**CITY OF DULUTH**  
Planning Division

**STAFF REPORT**

<b>File Number</b>	PL 13-165	<b>Contact</b>	Jenn Reed Moses, jmoses@duluthmn.gov	
<b>Application Type</b>	Planning Review	<b>Planning Commission Date</b>	February 11, 2014	
<b>Deadline for Action</b>	<b>Application Date</b>	December 13, 2013	<b>60 Days</b>	February 11, 2014
	<b>Date Extension Letter Mailed</b>	December 20, 2013	<b>120 Days</b>	April 12, 2014
<b>Location of Subject</b>	609 W Central Entrance			
<b>Applicant</b>	Members Cooperative Credit Union	<b>Contact</b>	218-625-8511, heikt@membersccu.org	
<b>Agent</b>	George Janssen	<b>Contact</b>	gjanssen@marketpointecre.com	
<b>Legal Description</b>	010-3182-00010			
<b>Site Visit Date</b>	N/A	<b>Sign Notice Date</b>	January 28, 2014	
<b>Neighbor Letter Date</b>	December 31, 2013	<b>Number of Letters Sent</b>	11

The applicant is proposing a new 4,400 square foot credit union with three drive-through lanes.

revision/issue  
**SITE PLAN**  
sheet number  
**1** of 3

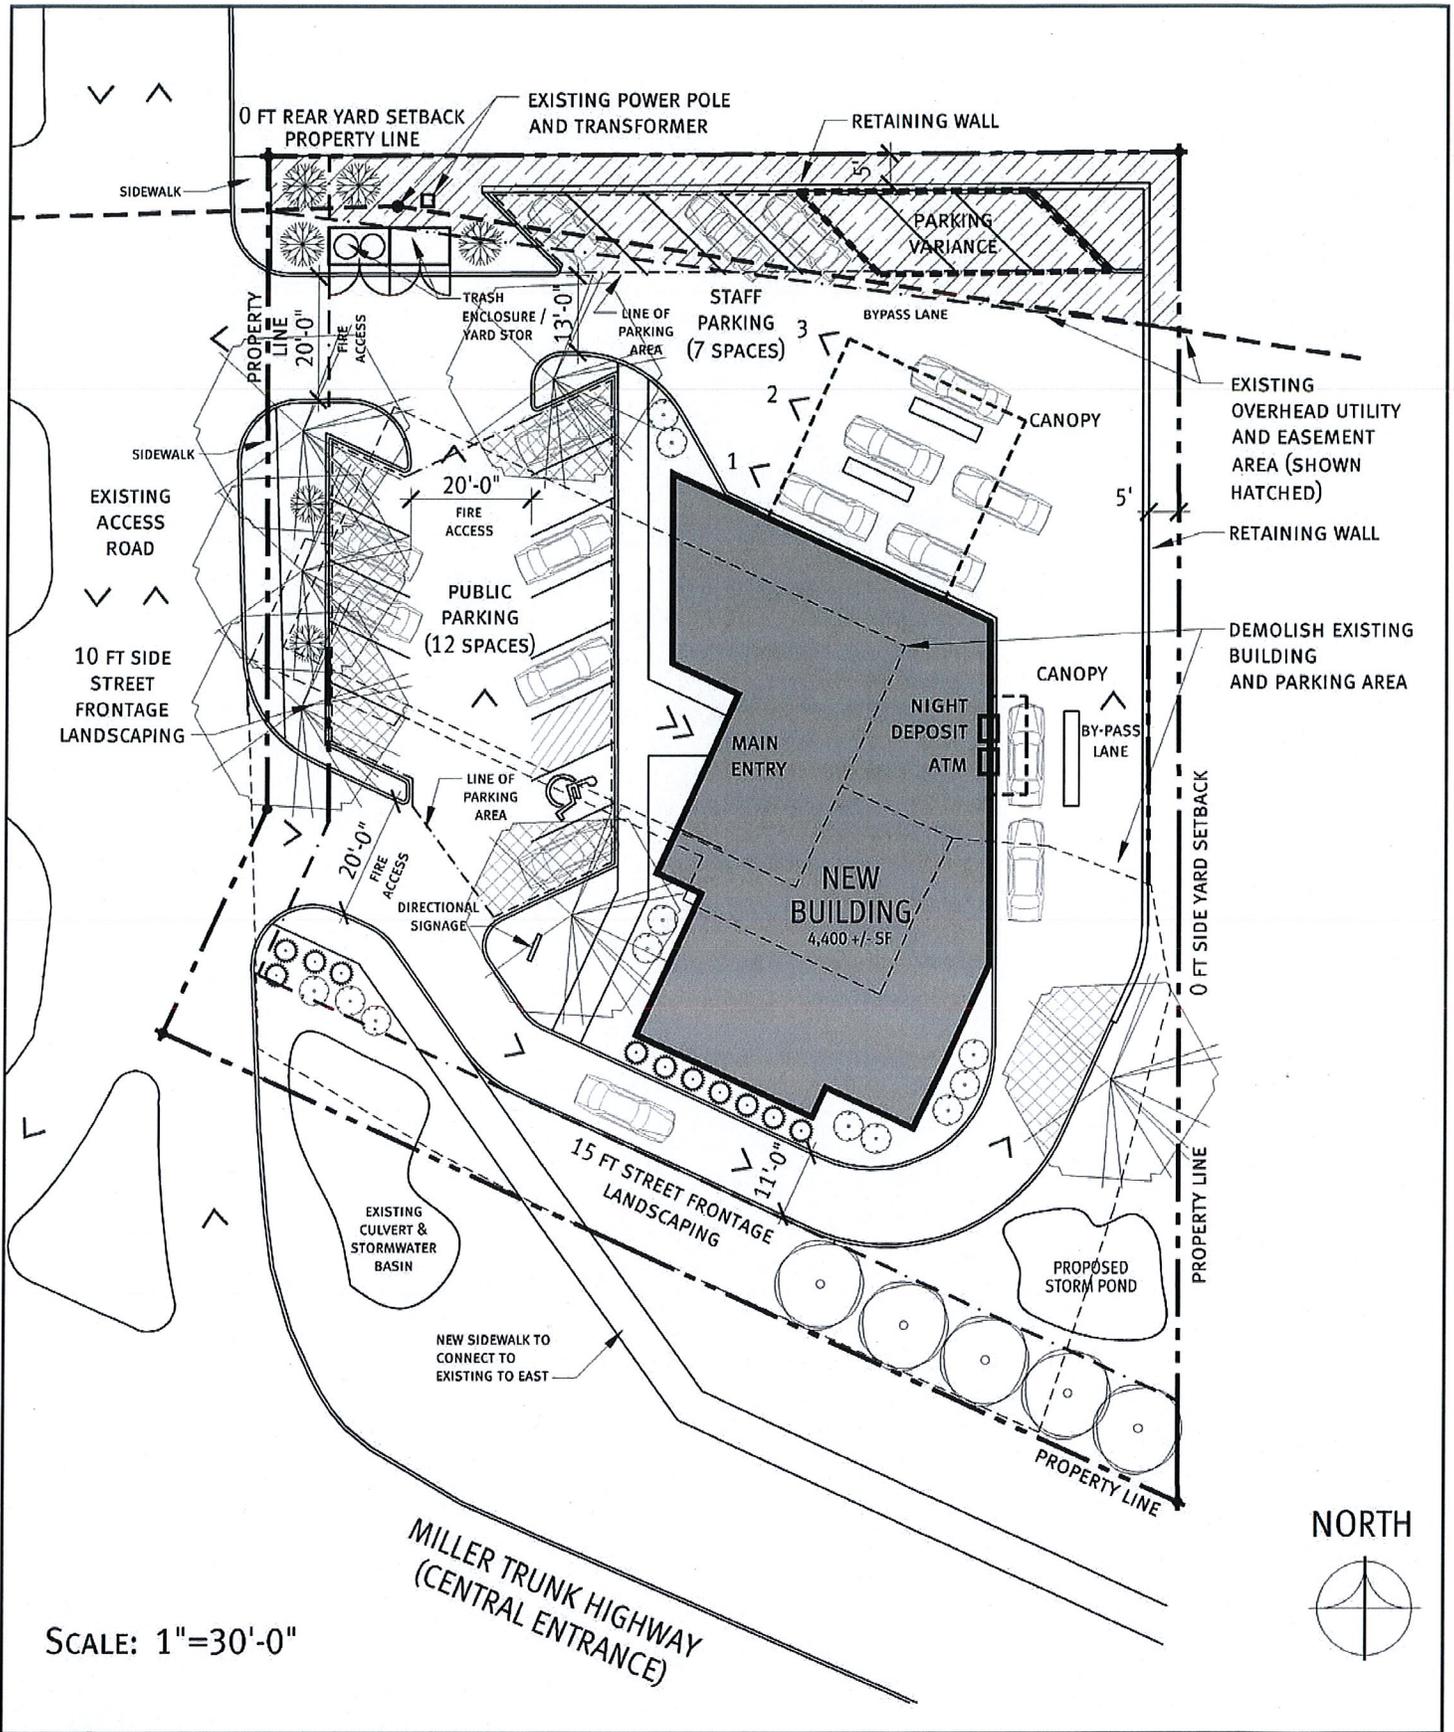
- 3.) 50-23 - Site plan includes an on-site sidewalk, a sidewalk along Central Entrance, and sidewalks along the property line with the existing access road to Cub Foods. To ensure safe pedestrian access, sidewalk from Central Entrance should include striping where it crosses the drive-through lane.

- 4.) 50-24 - Site plan shows 19 parking spaces, two spaces over the maximum limit. Applicant has applied for a variance to the maximum parking requirement. Temporary snow storage will be provided at the staff parking stalls with immediate snow removal off site.

- 6.) 50-26 - Trash enclosures are located in the rear of the property and will be screened. Retaining walls are shown along the north and east of the property and will be less than 6 feet high. All screening and walls will need to be verified at the time of building permit application to ensure they meet UDC requirements.

- Do you know the height of the building?
- How tall will the retaining walls be?
- Where will snow be stored? Usually we ask people to indicate a snow storage area on the site plan, and I didn't see one.
- Are you proposing any exterior lighting?

- 1.) The project be limited to, constructed, and maintained according to the Site Plan dated January 30, 2014.
- 2.) Sidewalk from Central Entrance include striping where it crosses the drive-through lane.
- 3.) Applicant comply with UDC parking maximums, or apply for and receive a variance to those requirements.
- 4.) Screening and lighting requirements be verified prior to receiving a building permit.
- 5.) Any alterations to the approved plans that do not alter major elements of the plan may be approved by the Land Use Supervisor without further Planning Commission; however, no such administrative approval shall constitute a variance from the provisions of Chapter 50.

Height of the building: 1 story / 20 ft +/-  
Retaining wall heights: 6 ft or less  
Snow storage: Temporary snow storage will be provided at the staff parking stalls with immediate snow removal off site  
Exterior lighting: Exterior lighting will be provided by design-build contractor and will meet UDC requirements
